**SUNDRY NOTICES AND REPORTS ON WELLS**  
*Do not use this form for proposals to drill or to re-enter an abandoned well. Use form 3160-3 (APD) for such proposals.*

1. Type of Well <input checked="" type="checkbox"/> Oil Well <input type="checkbox"/> Gas Well <input type="checkbox"/> Other		8. Well Name and No. COTTON DRAW 33 FED 1H	
2. Name of Operator DEVON ENERGY PRODUCTION CO		9. API Well No. 30-025-41263-00-X1	
3a. Address 333 WEST SHERIDAN AVE OKLAHOMA CITY, OK 73102		3b. Phone No. (include area code) Ph: 405-228-7203	
4. Location of Well (Footage, Sec., T., R., M., or Survey Description) Sec 33 T24S R32E NWNW 330FNL 1295FWL 32.150032 N Lat, 103.663966 W Lon		10. Field and Pool, or Exploratory PADUCA	
		11. County or Parish, and State LEA COUNTY, NM

Cotton Draw Unit 33 Fed 1H – BOP change procedure

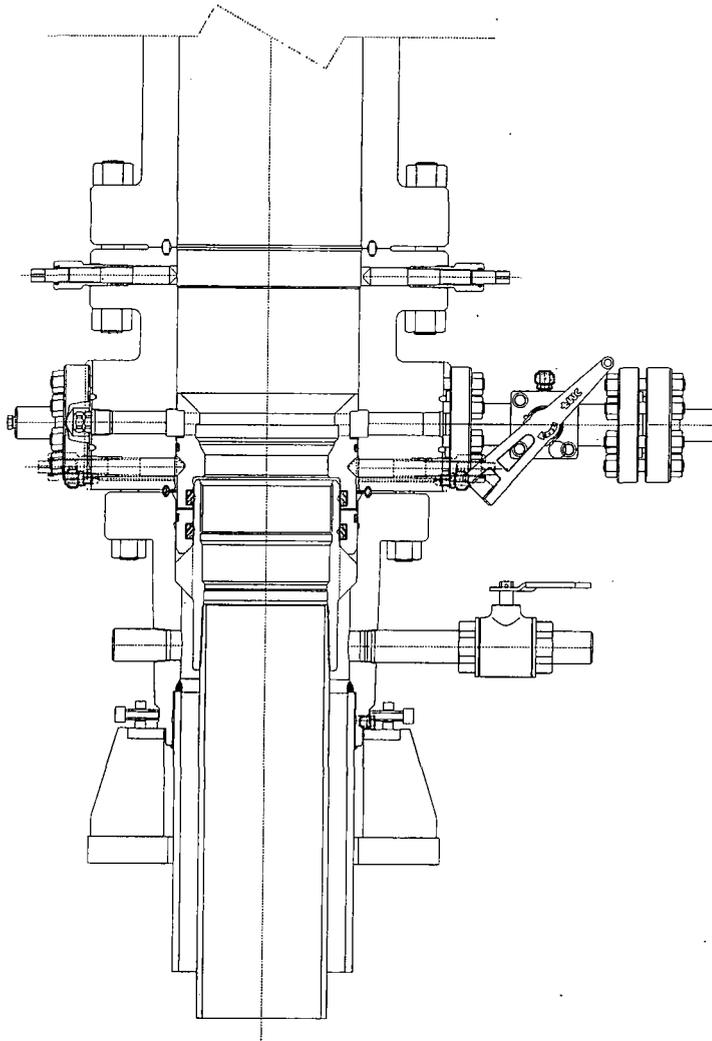
Devon energy requests to use FMC uni-head system. A multibowl wellhead is being used.

The BOP will be tested per Onshore Order #2 after installation on the surface casing which will cover testing requirements for a maximum of 30 days. If any seal subject to test pressure is broken the system must be tested.

Devon proposes using a multi-bowl wellhead assembly (FMC Uni-head). This assembly will only be tested when installed on the surface casing. Minimum working pressure of the blowout preventer (BOP) and related equipment (BOPE) required for drilling below the surface casing shoe shall be 3000 (3M) psi. Wellhead will be installed by FMC's representatives. If the welding is performed by a third party, the FMC's representative will monitor the temperature to verify that it does not exceed the maximum temperature of the seal. FMC representative will install the test plug for the initial BOP test. FMC will install a solid steel body pack-off to completely isolate the lower head after cementing intermediate casing. After installation of the pack-off, the pack-off and the lower flange will be tested to 5M, as shown on the attached schematic. Everything above the pack-off will not have been altered whatsoever from the initial nipple up. Therefore the BOP components will not be retested at that time. If the cement does not circulate and one inch operations would have been possible with a standard wellhead, the well head will be cut and top out operations will be conducted.

3. **Operator has proposed a multi-bowl wellhead assembly. This assembly will only be tested when installed on the surface casing. Minimum working pressure of the blowout preventer (BOP) and related equipment (BOPE) required for drilling below the surface casing shoe shall be 3000 (3M) psi.**

- a. **Wellhead shall be installed by manufacturer's representatives, submit documentation with subsequent sundry.**
  - b. **If the welding is performed by a third party, the manufacturer's representative shall monitor the temperature to verify that it does not exceed the maximum temperature of the seal.**

- c. **Manufacturer representative shall install the test plug for the initial BOP test.**
  - d. **Operator shall perform the intermediate casing integrity test to 70% of the casing burst. This will test the multi-bowl seals.**

- e. **If the cement does not circulate and one inch operations would have been possible with a standard wellhead, the well head shall be cut off, cementing operations performed and another wellhead installed.**
